Comments on the February 2007 Draft Specification
for High-Efficiency Bathroom Sink Faucets

July 2007

Lavatory Faucet Flow Profile

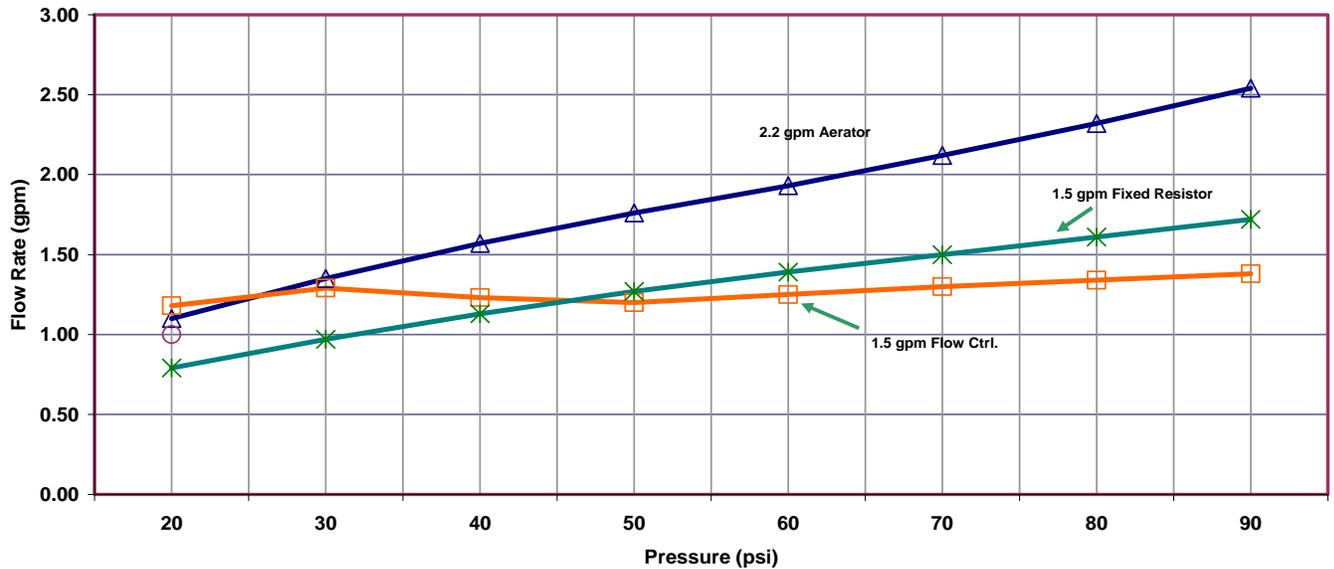
First, we would like to reiterate our verbal comments regarding the need to retain a minimum flow rate requirement. We feel that allowing the use of fixed orifice flow restrictors could result in user dissatisfaction. Please refer to the attached file which details flow rates using both fixed orifice and flow control device restrictors. 1.5 gpm fixed orifice restrictors can result in flow rates considerably less than 1 gpm (0.79 gpm) at 20 psi running pressure when taking upstream restriction from the faucet into account. With the same upstream restriction, a variable flow control device will result in a flow rate of 1.18 gpm at 20 psi, which is 33% higher than the fixed orifice flow.

As discussed, resistance from the faucet upstream of the aerator is a valid concern. As the data shows, a 1.5 gpm variable flow control device flows at 1.25 gpm @ 60 psi when installed on a single lever bathroom sink faucet and a drop below 1.2 gpm at 20 psi. Faucets with different valve configurations could provide even more restriction.

1. Revise the minimum flow rate from 1.2 gpm at 20 psi to 1.0 gpm at 20 psi
2. Eliminate the +/- 0.1 gpm tolerance requirement at 60 psi from the stated flow rate
3. In place of this tolerance on the high flow rate end of the specification, require that the DOE/EPACT '92 statistical evaluation procedure for maximum flow rates be employed as a method of determining compliance. Manufacturers currently conduct this testing in order to certify products with the DOE, so this would not create an additional burden.
